February 21, 2008

EA-08-046

SUBJECT: BYRON STATION, UNITS 1 AND 2 SPECIAL INSPECTION - DEGRADATION OF THE ESSENTIAL SERVICE WATER RISER PIPING TO THE COOLING TOWER BASIN 05000454/2007009(DRS) AND 05000455/2007009(DRS) AND PRELIMINARY WHITE FINDING

Picture No. 5 – 0E SX Riser Pipe- June 14, 2007

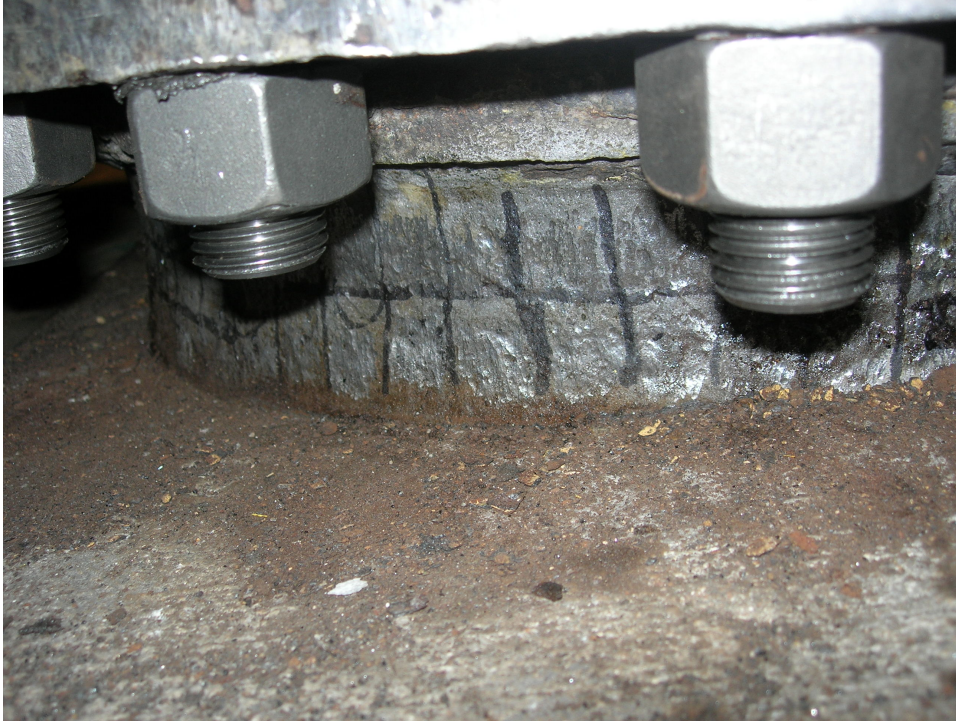
points approximately 1 inch in diameter (reference UT report 2007-005 and AR 00640363). The licensee recorded wall thickness measured at these two points (0.122 inch and 0.124 inch) that was substantially below the nominal pipe wall thickness of 0.375 inch. The licensee discussed the degraded 0E SX riser pipe at the Plant Health Committee (PHC) meeting on June 25, 2007, and the PHC recommended repair of the degraded SX riser pipes, but no repair work was accomplished prior to the dual Unit shutdown. After shutdown, the team observed extensive corrosion present on the 0E SX riser pipe.
